In Reply Refer To:  
HSST/ WZ-308

This is in response to your June 1, 2011, correspondence requesting the Federal Highway Administration's (FHWA) acceptance of your company's DSB100W Portable Sign Stand as a crashworthy traffic control device for use in work zones and elsewhere on the National Highway System. Accompanying your letter was the FHWA Office of Safety Design form and drawings of the stand. You requested that we find this device acceptable for use on the NHS under the provisions of National Cooperative Highway Research Program Report 350 "Recommended Procedures for the Safety Performance Evaluation of Highway Features."

Based on the enclosed information and previous test data, we are seeking acceptance of sign stand DSB100W. We believe this to be a reasonable request because the only difference between this and the already accepted DSB100 is the height of the sign bracket. The height of the "W" bracket is below the windshield impact zone and falls within the range of previously accepted stands. Therefore, we believe it is fair to assume that this stand configuration will perform as well as the original. As such, we contend that there will be no effect on the windshield

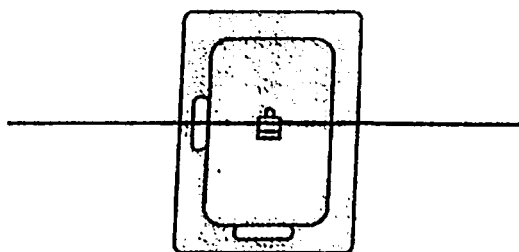
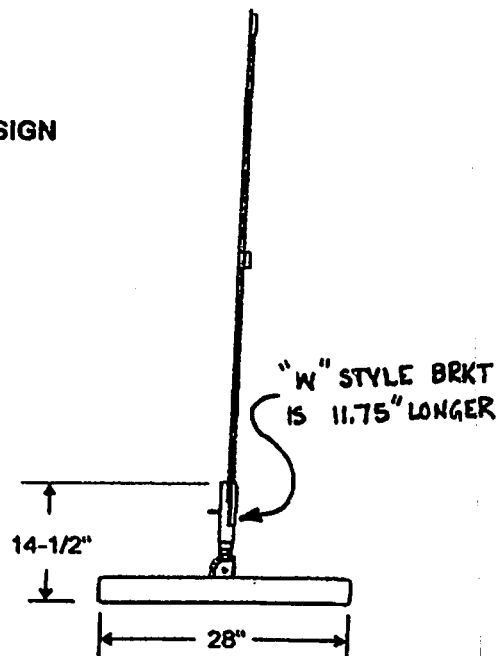
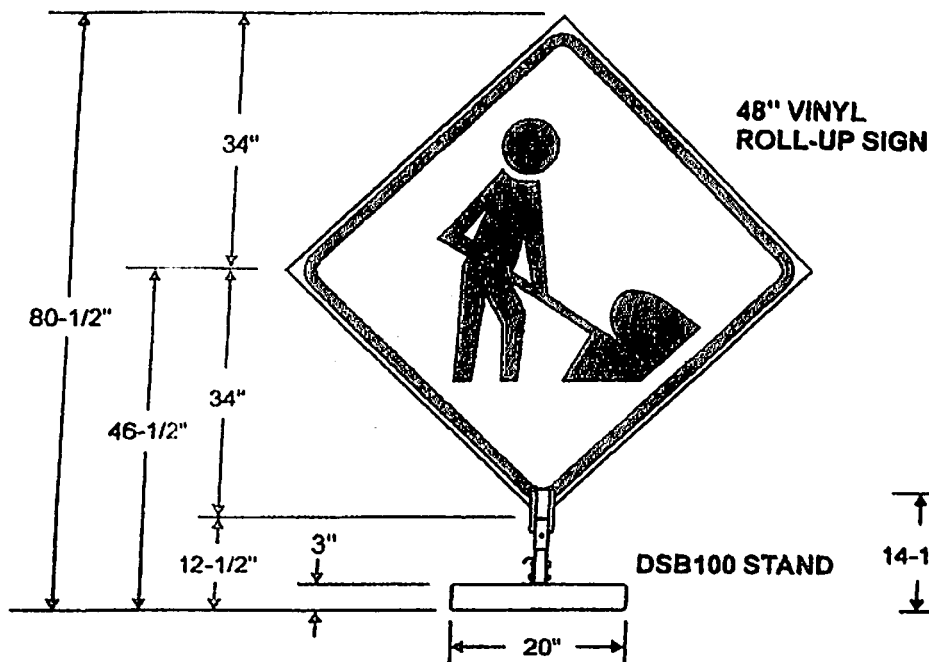
This inquiry is in regards to a previously tested and accepted stand, the DSB100. This stand was tested and accepted with a pocket latch bracket. We have another version of this same stand with a different, taller latch bracket. This same bracket has been accepted on a wide range of Dicke's X-footprint sign stands. For comparison purposes, the similarities between these stands may be seen below in Table #1.
